INSPECTION REPORT

DATE OF INSPECTION: September 6, 2023

PERMITTEE - MINE: Westmoreland Beulah Mine - Beulah Mine

PERMITS INSPECTED: KRSB-8603, KRSB-8802

Figure 1: The area too high in elevation in Grade Approval Gold-2-2023 is outlined in yellow.

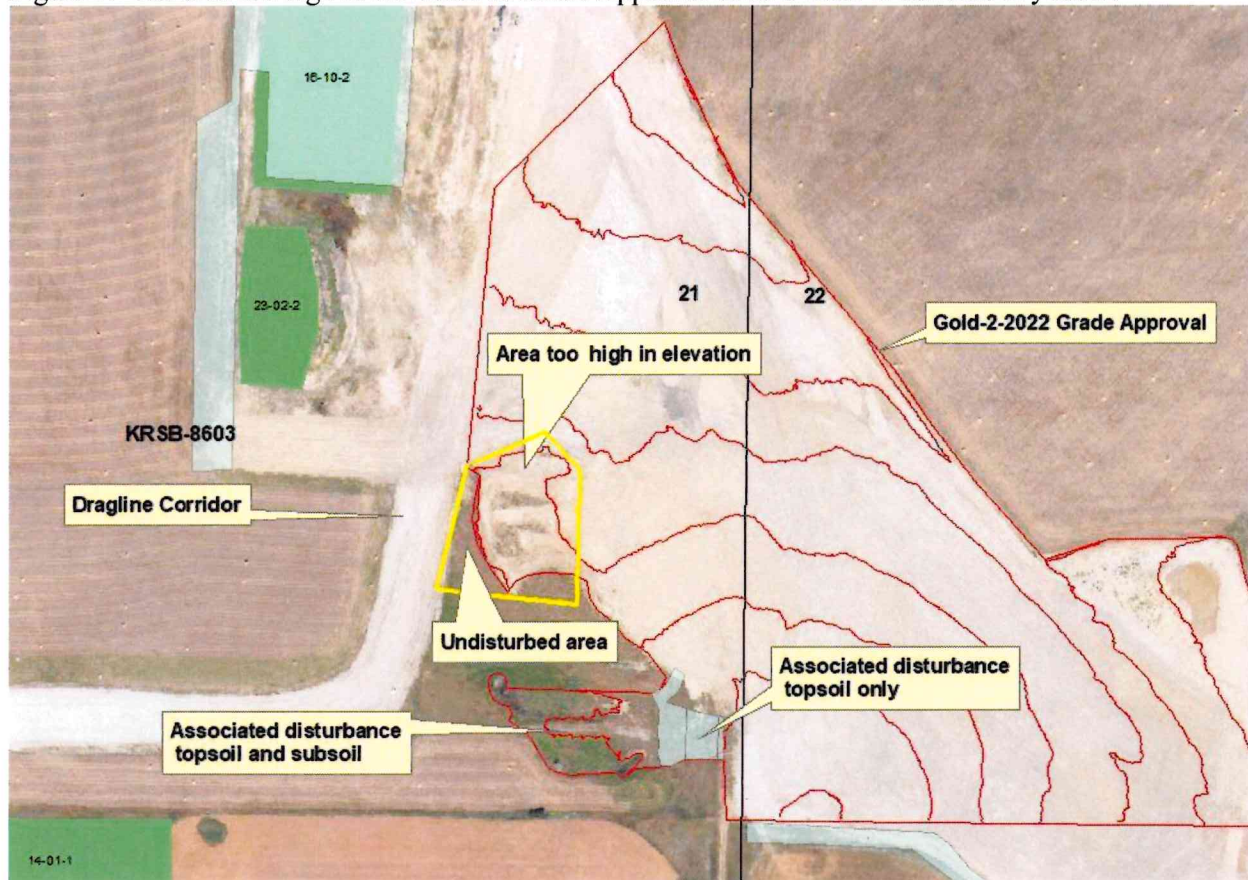
Additional shaping is needed on a portion of this grade approval in the southeast corner of the NE¼ of Section 21. Figure 1 below depicts this area. Undisturbed land between the grade approval request and the dragline corridor is several feet higher in elevation than the grade approval area to the north. This area needs to be lowered in elevation to blend the grade approval request area and dragline corridor into adjacent undisturbed lands. WBM could make a written request to remove topsoil and subsoil from this undisturbed area. The topsoil could be placed on that portion of the grade approval area requiring topsoil only in the southeast corner of the NE¼ of Section 21. This could be accomplished prior to grade approval because the grade approval process does not apply to areas affected by associated mining disturbance, which is the case in this instance. Subsoil from this area could then be placed on the associated disturbance area requiring subsoil and topsoil in the southeast corner of the NE¼ of Section 21. Overburden under the subsoil could then be used where needed along the north and south sides of the grade approval request area. A corridor would need to be maintained through the area requiring topsoil only to maintain access to the area requiring both topsoil and subsoil located to the west. The pre-mine soils map, Exhibit 2.4.7 in the permit, indicates that there is 12 to 20 inches of topsoil and 40 to 48 inches of subsoil in this area. The topsoil and subsoil respread depths on areas of associated disturbance are to be determined by the depths present prior to disturbance (detailed soil survey).
